CONSTRUCTION BULLETIN # 03

Client: Abla Griffin Partnership
 Project Name: Kelley Elementary Saferoom Addition
 Project Number: 2022-04164-00

December 30, 2022

NEW ADDITION
 KELLEY ELEMENTARY
 SCHOOL

T100

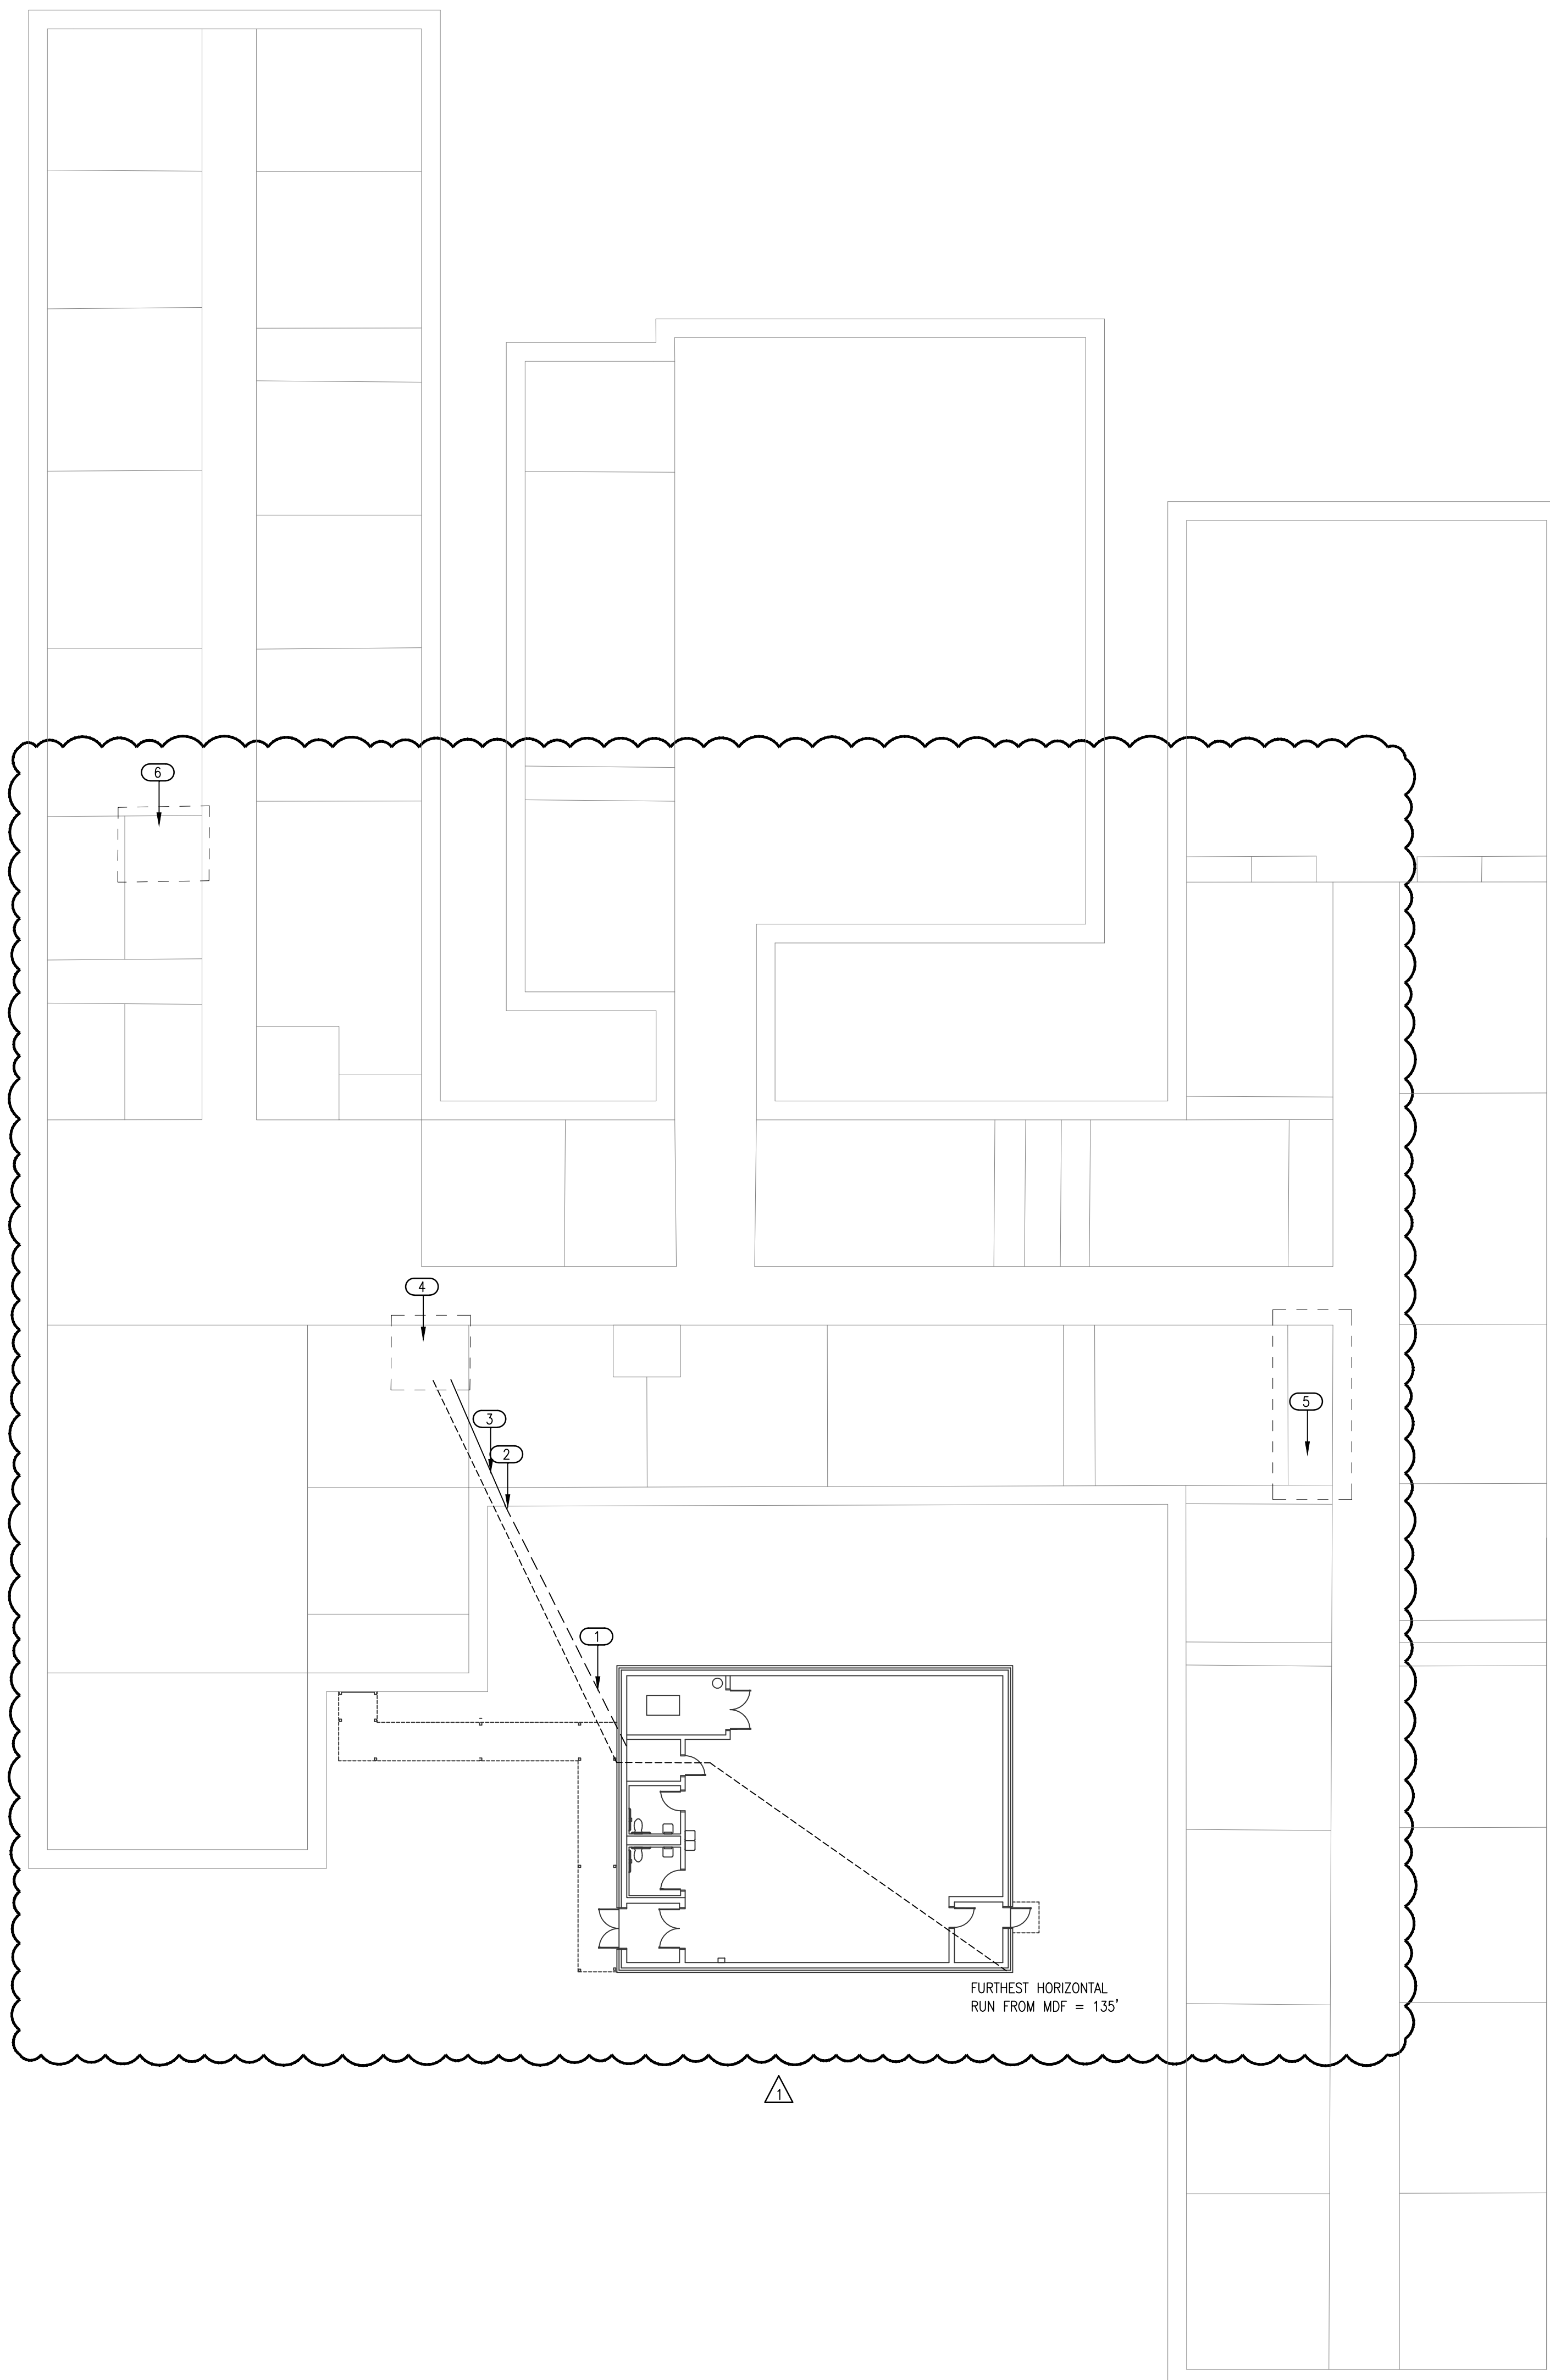
Item No.	Description	Attachment
1	Refer to drawings for changes shown in clouds and deltas.	T100
